# Access Compliance Report

## Public Rights-of-Way

### (Curb Ramps)

Intersection ID: 10023487	Main Street: CIRCUMFERENTIAL_RD	Cross Street: N/A	Location:	N
ADA ID: F6A694893D63	Ramp Type: PerpDiag	Initial Pass/Fail: Fail	Overall Compliance: No	Severity Score: 25
Codes/Mitigation Info/Possible Solution		Field Measurements/Component Compliance

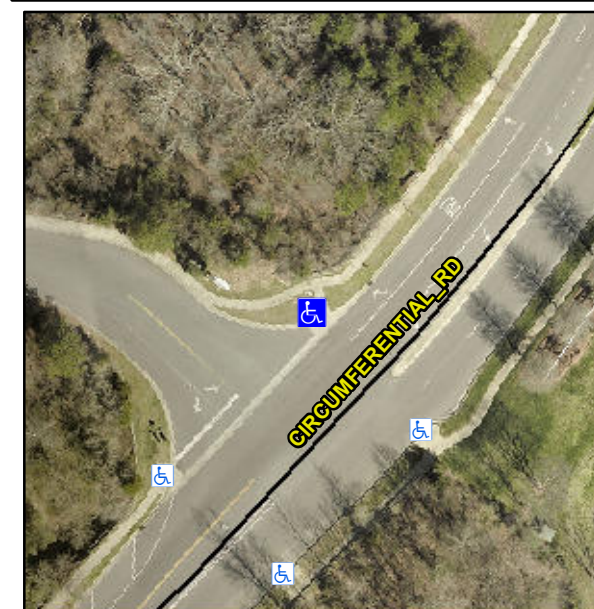
**Not Found, R304.2.2, R304.5.3**

Compliance	Description	Data	Compliance	Description	Data
N/A	Ramp Length (in)	61.0	No	Ramp Slope (%)	9.3
Yes	Ramp Width (in)	48.0	No	Ramp XSlope (%)	5.9
N/A	Flare Type LT	N/A	N/A	Flare Type RT	N/A
N/A	Flare Slope LT (%)	N/A	N/A	Flare Slope RT (%)	N/A
N/A	Flare Traversable LT?	N/A	N/A	Flare Traversable RT?	N/A
N/A	Landing Length (in)	N/A	N/A	DWS Provided?	N/A
N/A	Landing Width (in)	N/A	N/A	DWS Contrast?	N/A
N/A	Landing Slope (%)	N/A	N/A	DWS Length (in)	N/A
N/A	Landing X Slope (%)	N/A	N/A	DWS Full Width?	N/A
N/A	Landing Curb? (Y/N)	N/A	N/A	DWS Offset (in)	N/A
N/A	Shared Landing?	N/A			
N/A	Gutter Ponding?	N/A	N/A	Gutter Slope (%)	N/A
N/A	Gutter Lip Ht (in)	N/A	N/A	Gutter X Slope (%)	N/A
N/A	Painted X Walk1?	No	N/A	Painted X Walk2?	No
	X Walk 1 Direction	To SW		X Walk 2 Direction	To SE
N/A	X Walk 1 Width (in)	N/A	N/A	X Walk 2 Width (in)	N/A
	X Walk 1 Slope (%)	1.7		X Walk 2 Slope (%)	1.0
	X Walk 1 X Slope (%)	3.0		X Walk 2 X Slope (%)	3.7

**Remove & Replace Curb Ramp With Two New Directional Ramps or Equivalent.**
